**METROPOLITAN GOVERNMENT OF NASHVILLE AND DAVIDSON COUNTY**

**STAFF RECOMMENDATION**  
**1320 Rosa L. Parks Boulevard**  
**May 21, 2014**

**Application:** New-construction-infill  
**District:** Germantown Historic Preservation Zoning Overlay  
**Council District:** 19  
**Map and Parcel Number:** 08112044400  
**Applicant:** John Barnett  
**Project Lead:** Paul Hoffman, paul.hoffman@nashville.gov

<p><b>Description of Project:</b> The applicant proposes a mixed-use building with three (3) retail units and twenty-four (24) apartment units.</p> <p><b>Recommendation Summary:</b> Staff recommends approval of the proposed development at 1320 Rosa L. Parks Boulevard, with the conditions:</p> <ul style="list-style-type: none"> <li>• That Staff approve a brick sample;</li> <li>• Double windows will have a four to six inch (4-6”) mullion between them; and,</li> <li>• That Staff review proposed exterior lighting and location of trash containers.</li> </ul> <p>Staff finds that the project meets Sections 3.0 and 5.0 of the <i>Germantown Historic Preservation Zoning District: Handbook and Design Guidelines</i>.</p>	<p><b>Attachments</b>  <b>A:</b> Photographs  <b>B:</b> Site Plan  <b>C:</

**BASEMENT LEVEL GRADING AND DRAINAGE PLAN**

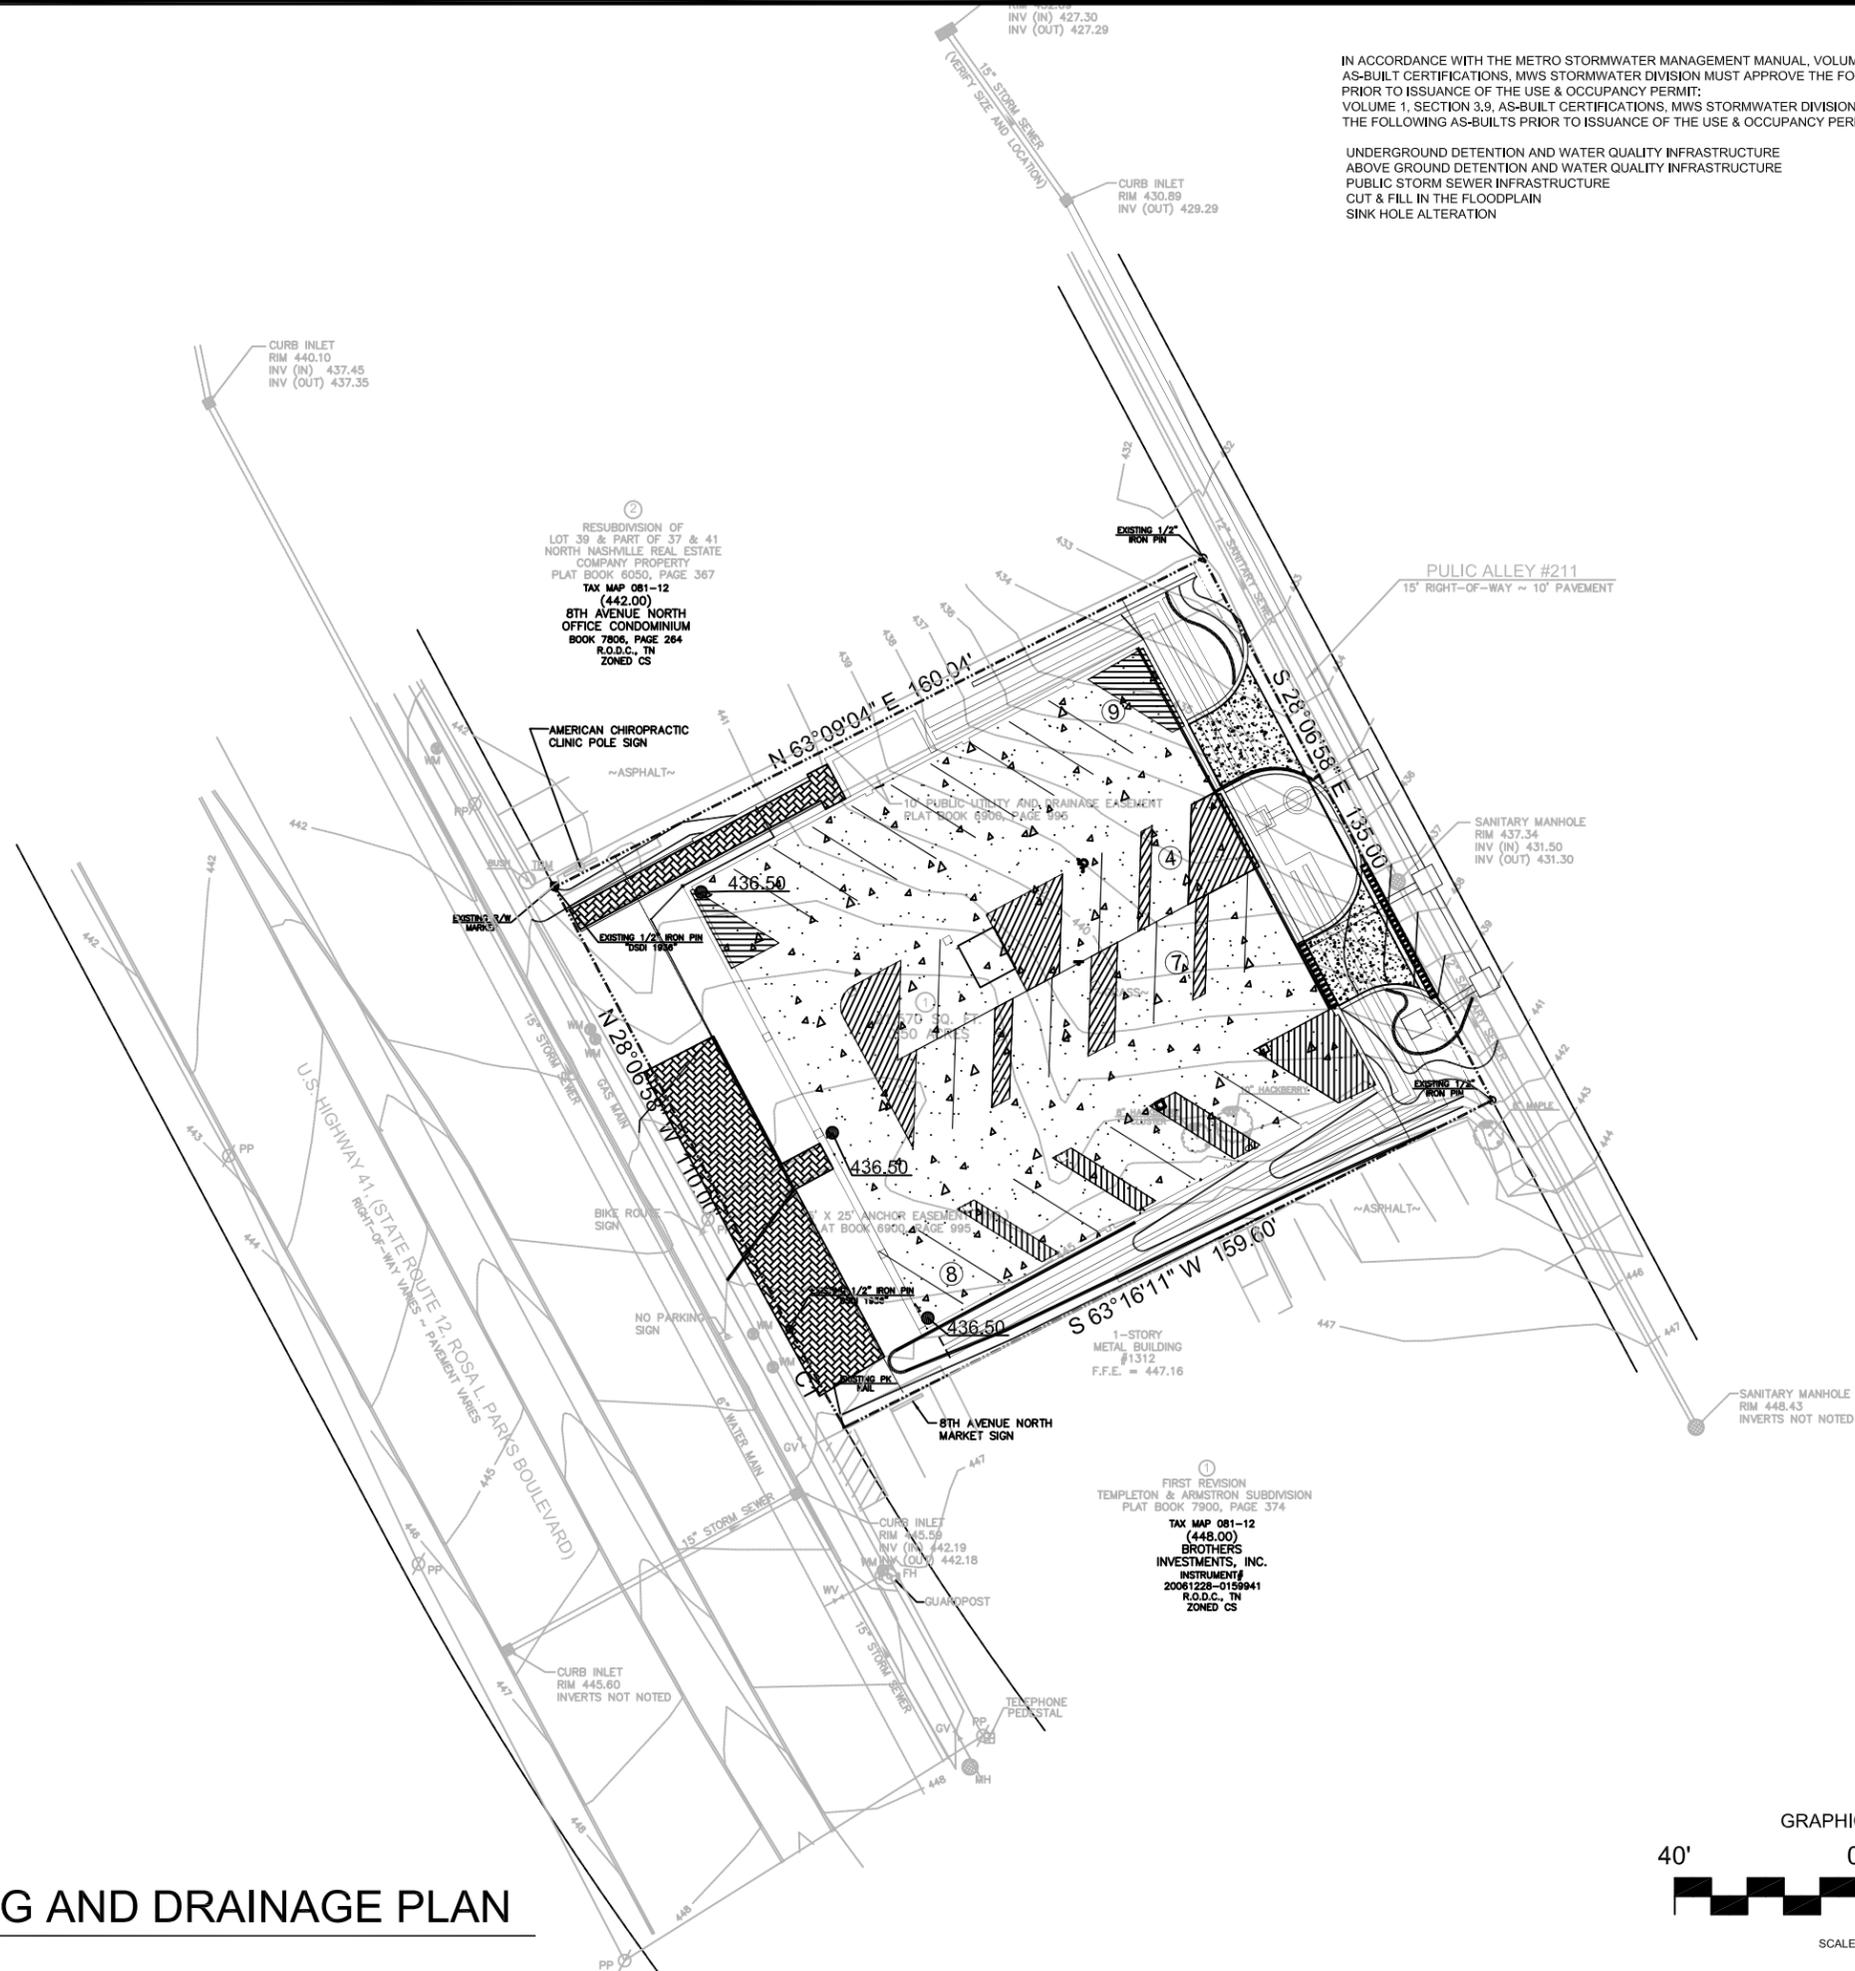
Site, Building Planning, Paving/Driveways/Parking Areas and Parking Lots: The building will be located approximately twenty-five feet (25') from the west property line (along Rosa L. Parks Boulevard) on an interior lot. The neighboring retail spaces are not historical or contributing, but the proposed building meets this contextual street setback. Having commercial space on the ground floor and close to the street helps to encourage pedestrian activity, as required by the design guidelines. The project includes a vehicular entrance to interior parking, which is not ideal but is the only way to access one level of the multi-level parking. This entrance is the minimum width required and by wrapping the storefront around to the side facing the vehicular entrance. The rear of the building is twenty feet (20') from the alley, which is the minimum required. Bulk regulations for CS zoning do not require side setbacks. The project meets section 3.2.2 and 5.3.

Fences/Walls: This project requires a concrete retaining wall along the north side of the project. The visual impact of the wall will be minimized by having it step up, as needed. This meets section 5.1.

Sidewalks: The existing sidewalk is proposed to be removed and a five foot (5') wide grass strip put in its place. A new eight foot (8') sidewalk will be laid between this median and the building's front parking to meet public work's standards. A patio area of concrete pavers will be between the sidewalk and the building. Staff finds this meets section 5.2.

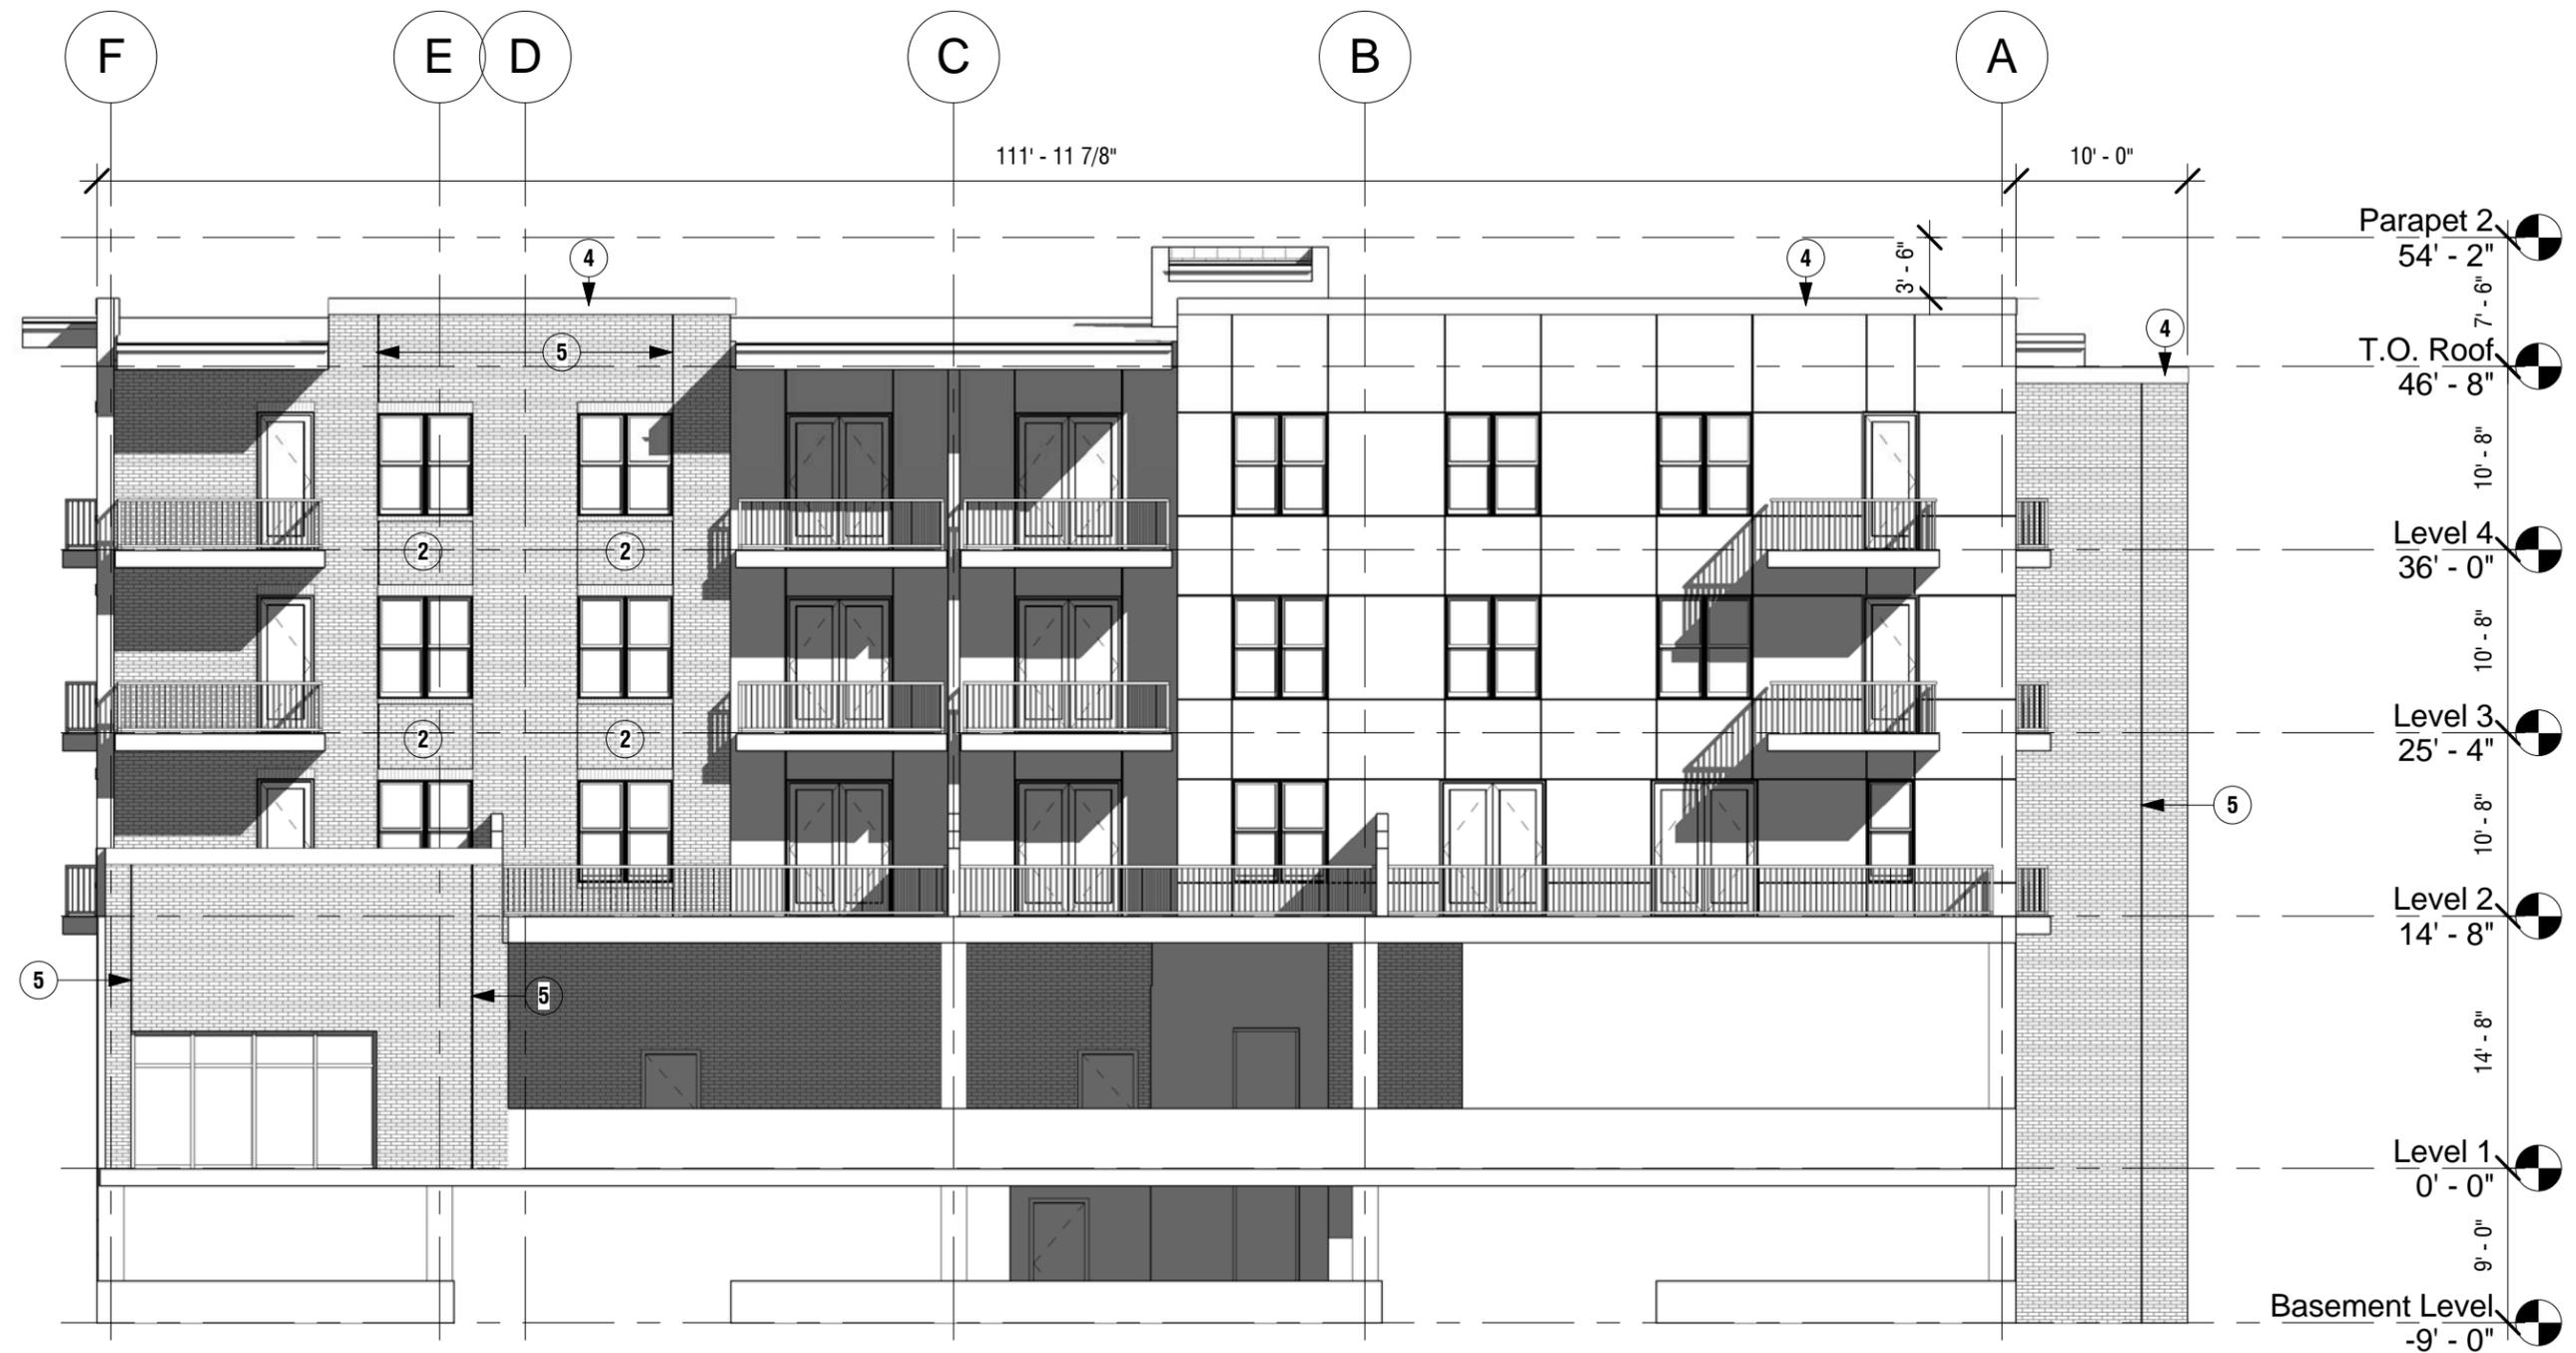
Façade Articulation: The ground floor is primarily glass with awnings. The upper levels, which sit back from the commercial area, have a rhythm of openings, including double doors, windows and balconies that match the rhythm found in the district. The side elevations have large areas of unbroken wall expanses; however, the expectation is that future development along Rosa Parks Boulevard will largely obscure views of the side elevations. 3.2.4.2.

Walls/Exterior Materials: The primary cladding is brick and cement fiber paneling. Staff requests review of a brick sample for final approval and that the cement fiber panels have a smooth face. The balconies will be trex with aluminum railings. A metal coping tops the building. There is no change in material from the foundation and the first floor; as often seen on commercial buildings. Staff finds the walls and exterior materials to meet section 3.3.

Doors & Windows: The storefronts are primarily glass with transoms and full-light doors. The windows on the residential upper stories are double pane, argon-filled, Solarban 60 clear glass with silver frames; they are twice as tall as they are wide, consistent with the historical proportions for windows. Staff recommends four to six inch (4" to 6") mullions between the double windows. The project meets section 3.4 and 3.5.

- That Staff approve a brick sample;
- Double windows will have a four to six inch (4-6") mullion between them; and,
- That Staff review proposed exterior lighting and location of trash containers.
